# Meeting Summary

## Kootenai River Habitat Restoration Program Modeling Subgroup Meeting

March 5 and 6, 2014

**Figure 2. Proposed construction staging for Bonners Ferry Islands and Straight Reach projects.**

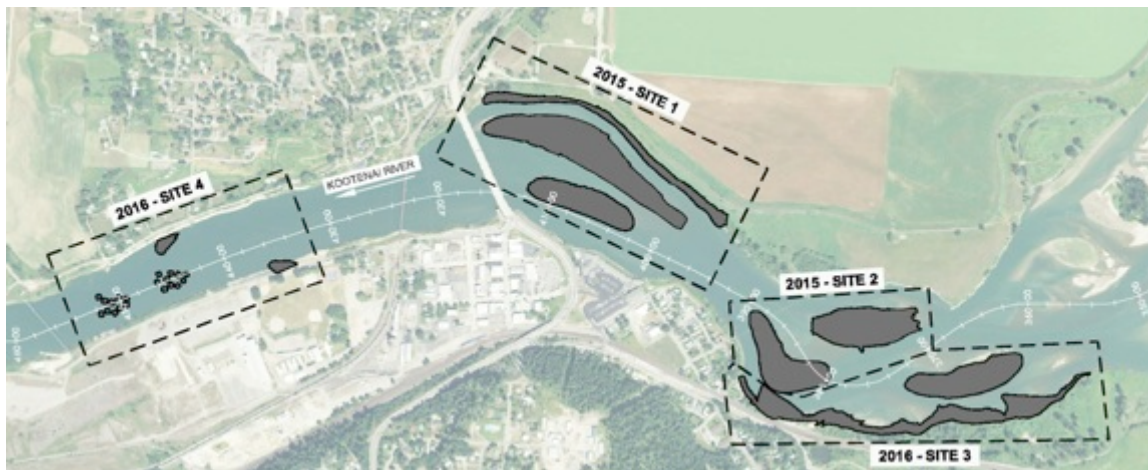
Matt reviewed an illustration of the planned construction implementation (Figure 2). In 2015 Site 1 and Site 2 will be constructed. All work will be conducted from the north bank of the river. The earthwork is designed to balance. Constructing in this order would allow for completion of structures and earthwork prior to excavating pools. The 2016 work would include work on the south bank and the entirety of the Straight Reach project.
